STATE OF NORTH CAROLINA DEPARTMENT OF TRANSPORTATION

February 24, 2005

SUBJECT:

Revised and New Guidelines for the

1-4 B

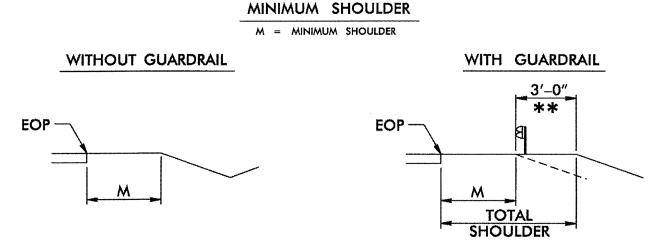
5. Chapter 1 - Section 4-B Usable and Graded Shoulders

NOTE: The use of 6 foot Shoulders rather than 5 foot where environmental constraints allow.

** WHERE ENVIRONMENTAL CONSTRAINTS ALLOW, 6-FOOT SHOULDERS SHOULD BE

UTILIZED RATHER THAN THE 5-FOOT SHOULDERS.

** WHEN GUARDRAIL IS WARRANTED, THE MINIMUM SHOULDER WIDTH IS INCREASED BY 3'-0" AS SHOWN IN THE ABOVE DIAGRAM.

ROADWAY DESIGN MANUAL	PART 1 1 - 7 D
FIGURE 4	FIG - 4

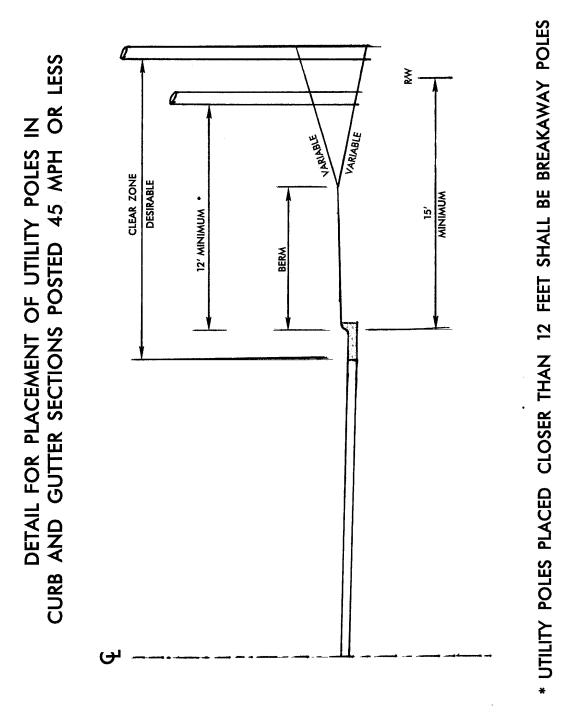
1. Chapter 1 - Placement of Utility Poles in Curb and Gutter Sections

NOTE: Clarification of utility pole placement as defined by the 2002 Roadway Design Guide.

For Curb and Gutter where posted speed is 45 MPH or less, all utility poles shall be placed outside the Clear Zone where practicable. If this cannot be achieved due to right of way restraints, the utility pole may be placed a minimum of 12 feet from the face of the curb. All utility poles that are placed closer than 12 feet shall be breakaway poles. See Figure 1-7D, F-4 for Detail.

FIGURE 1

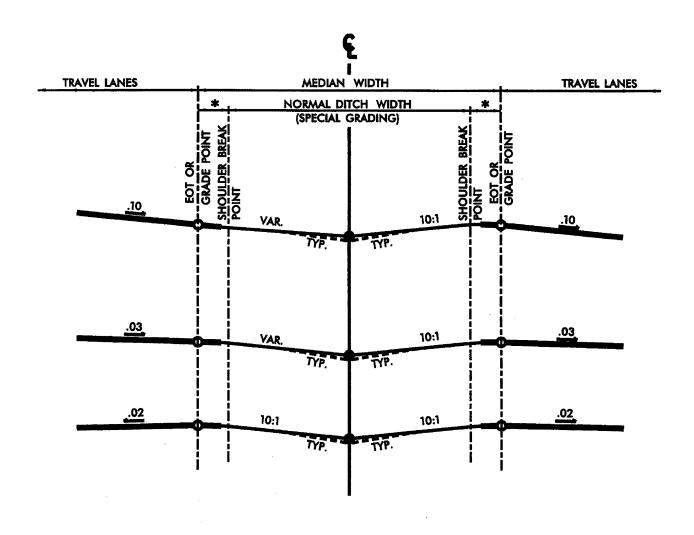
7. Chapter 3 – Section 6 Guardrail/ Guardrail Treatment in Median Locations Length

NOTE: Changes to special median grading.

Special grading in Superelevated locations shall have Standard Median Shoulder slopes (See Roadway Standard Drawings Nos. 560.01 and 560.02). Use a 10:1 slope from the higher median shoulder break point to establish the elevation at the center of the median. Next extend a slope from the lower median shoulder break point to the center of the median elevation, as established above, to complete the Median Cross-Section (See Part I, 3-6, Figure 1, of this manual for further information).

FIGURE 1 9 - 1 F - 1

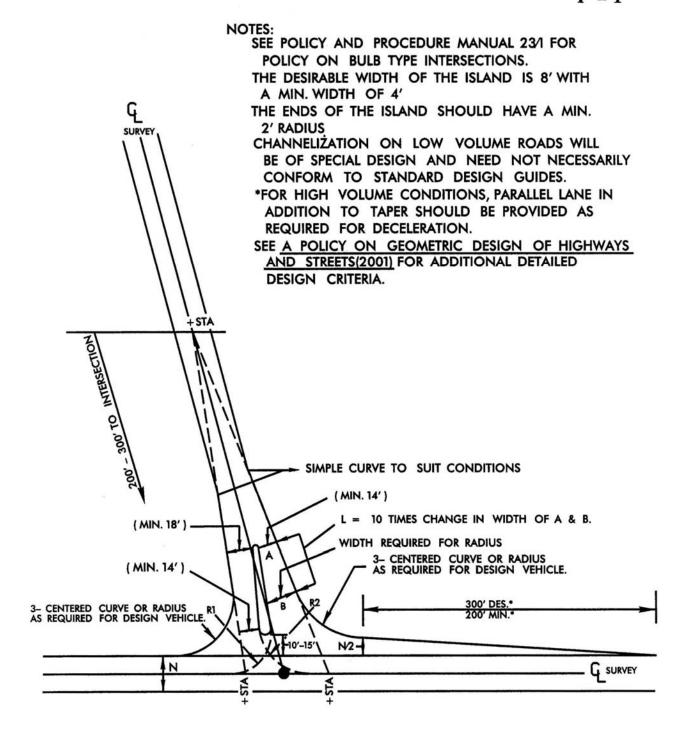
11. Chapter 9 - Section 1-F At Grade intersections

NOTE: Changes to figures 1 and 2
